Meeting Agenda Capital Investment Committee

Thursday, October 24, 2019

REQUEST FOR CONSTRUCTION CONTRACT CHANGE CHANGE ORDER NO. 2

Contract Number: 2017-0264
Project Name: Water Reclamation Facility
Modifications & Expansion

GRADING AND DRAINAGE PLAN
PANEL 5

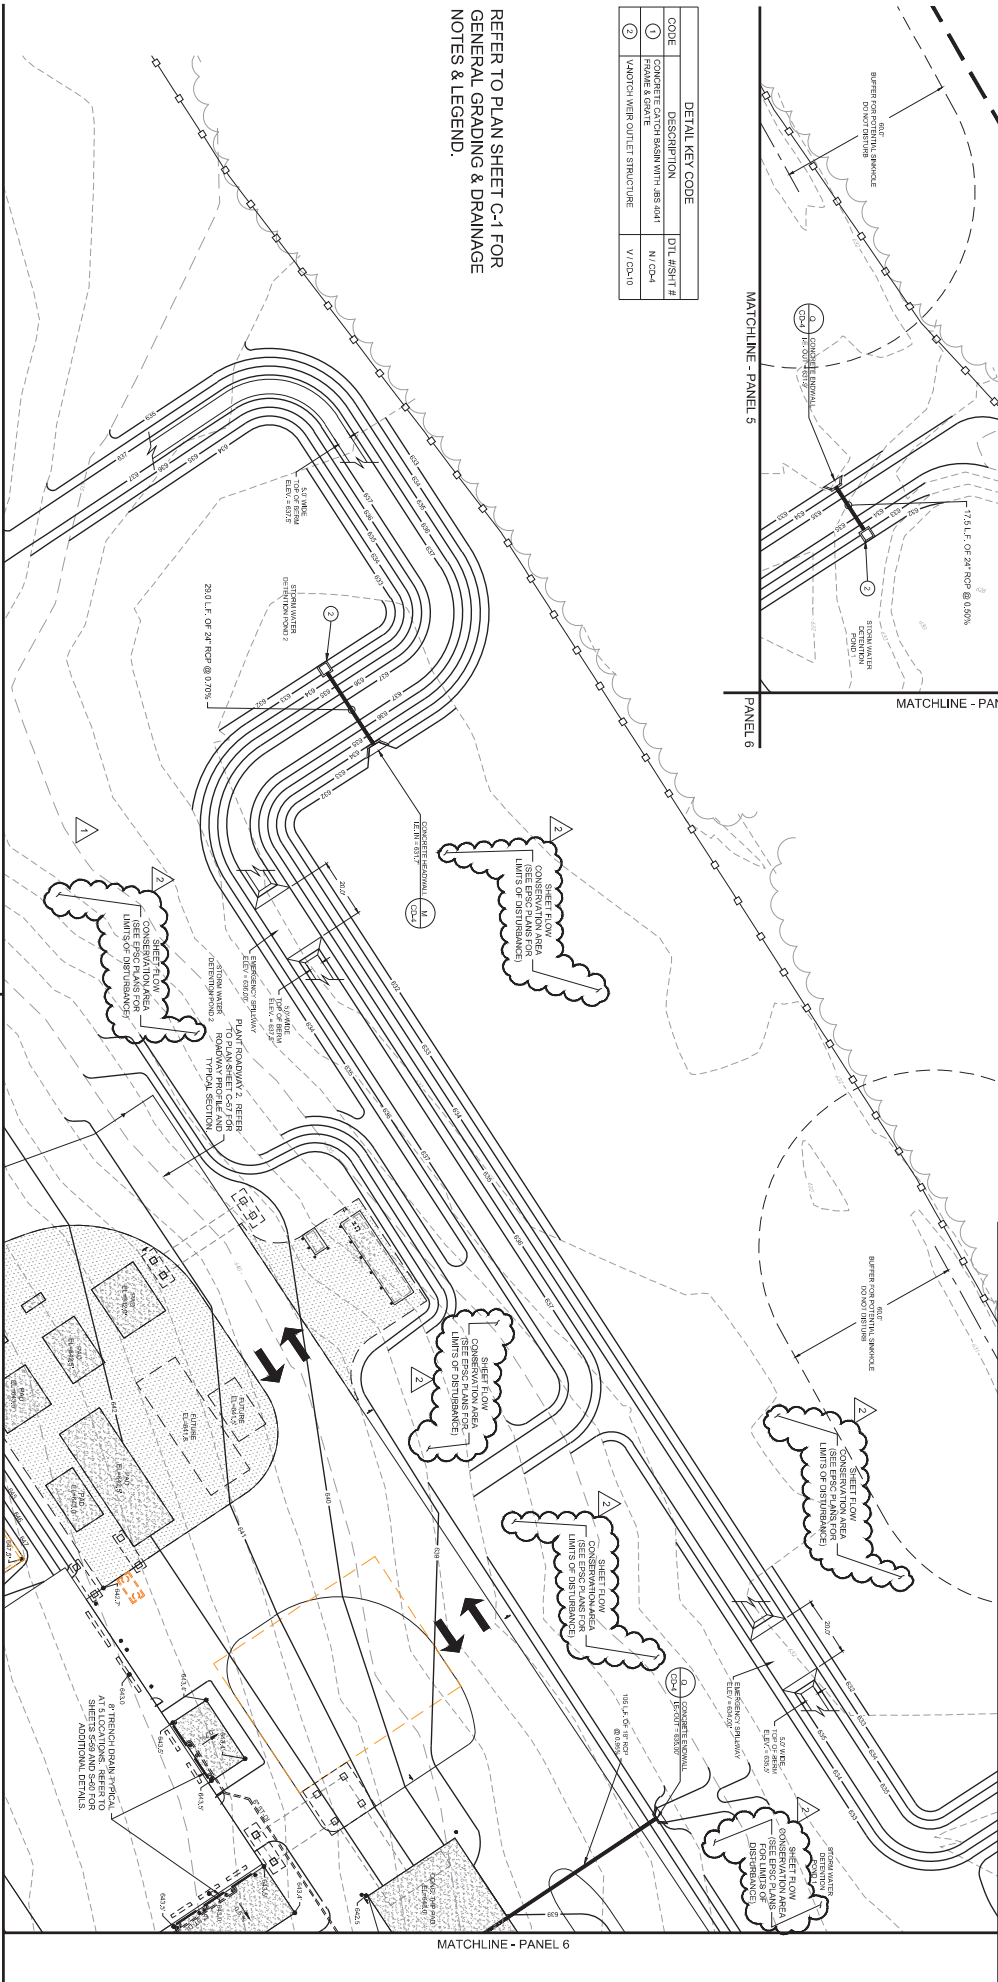
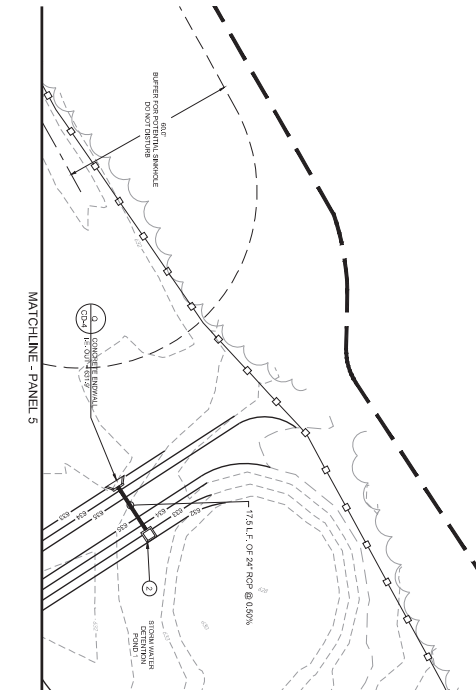
In working through the final details of the stormwater and erosion and sedimentation control design for the site with the City's Engineering Department, a few modifications had to be made to the civil drawings to satisfy their requirements. The modified drawings (C-32, C-42A, C-42B, C-42C, C-43A, C-43B, C-43C, and CD-9) are reissued as part of this construction change authorization (CCA). The changes, which are clouded, focus on more clearly delineating conservation areas to ensure they are not disturbed during construction and addition of a sediment trap in Pond 2. There are also modifications to the tables in the sediment pond detail to provide more detail.

In addition to the design drawing modifications, a few changes had to be made to the drawings in the SWPPP as well. The changes to the drawings in the SWPPP are either expansion on previous site information or the same as the changes to the contract drawings.

SK-1

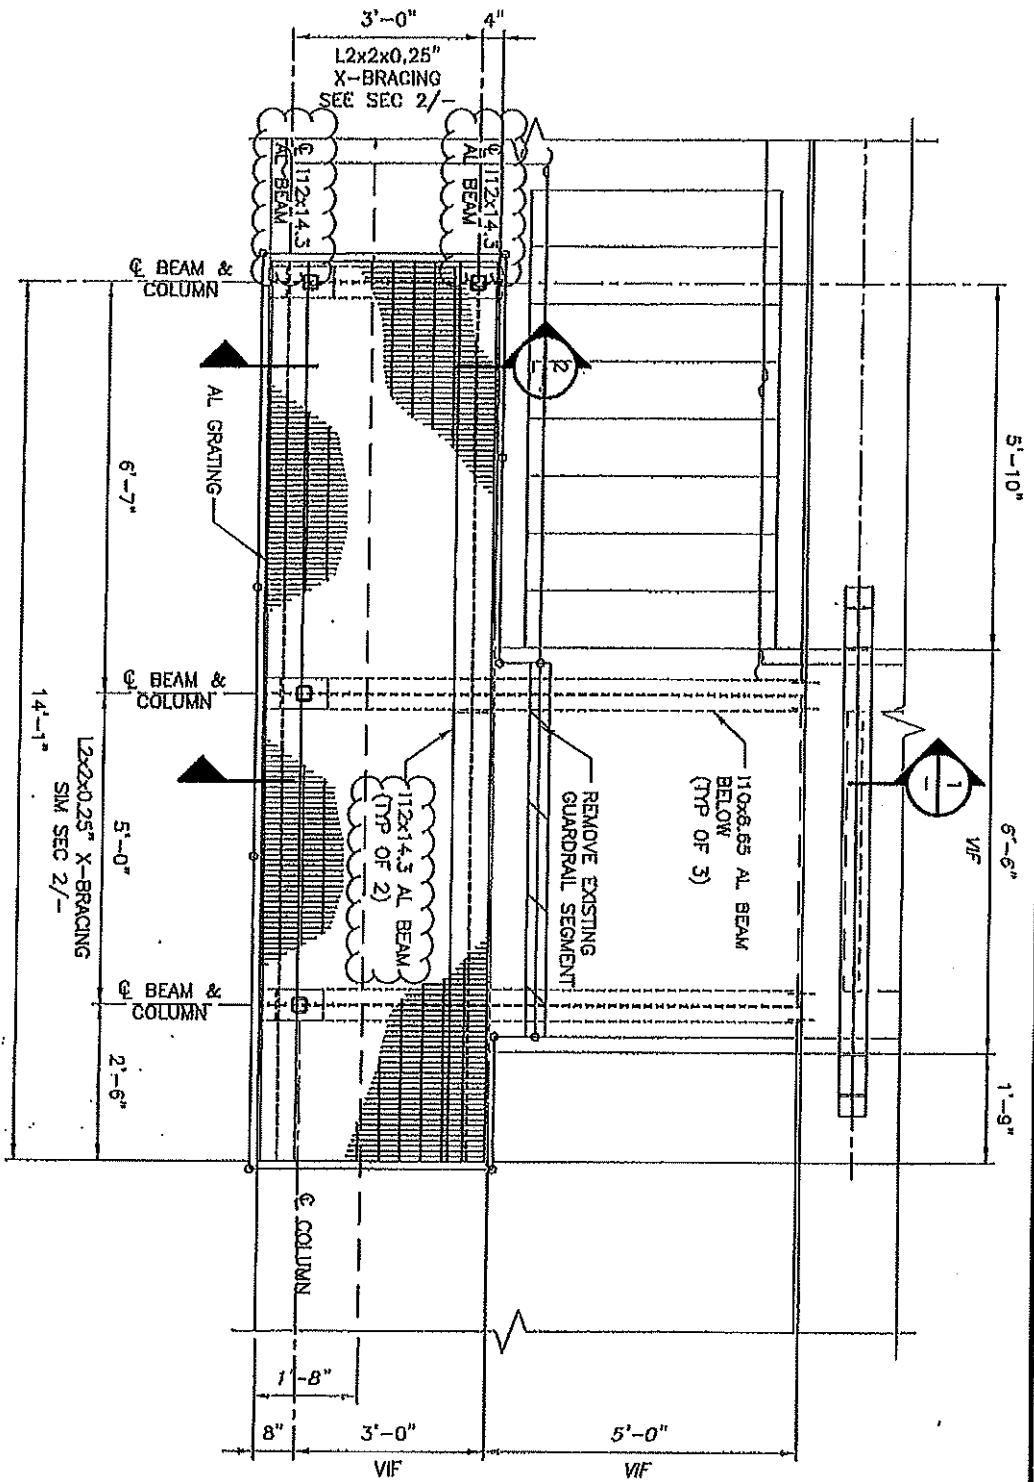
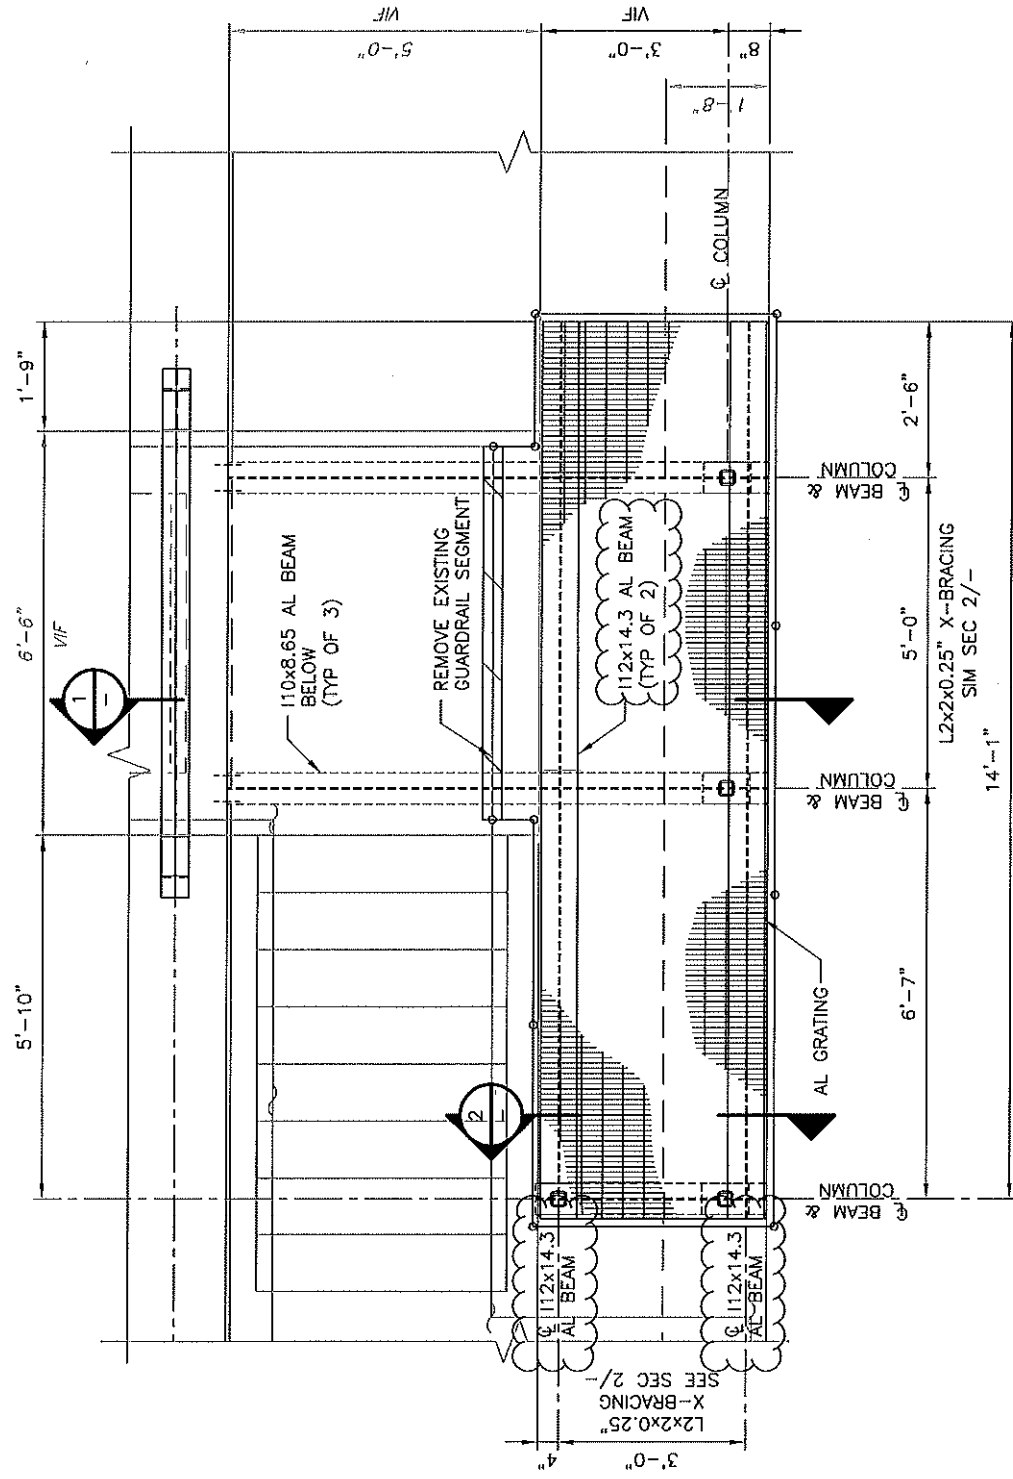
DESCRIPTION: At the request of the Contractor per RFI No. 008, item 1, the I14 x 16.0 aluminum support beams shown on Sections 1 and 2, Sh. S-13 may be revised to I12 x 14.3 with spacers per attached Figures SK-1 and SK-2.
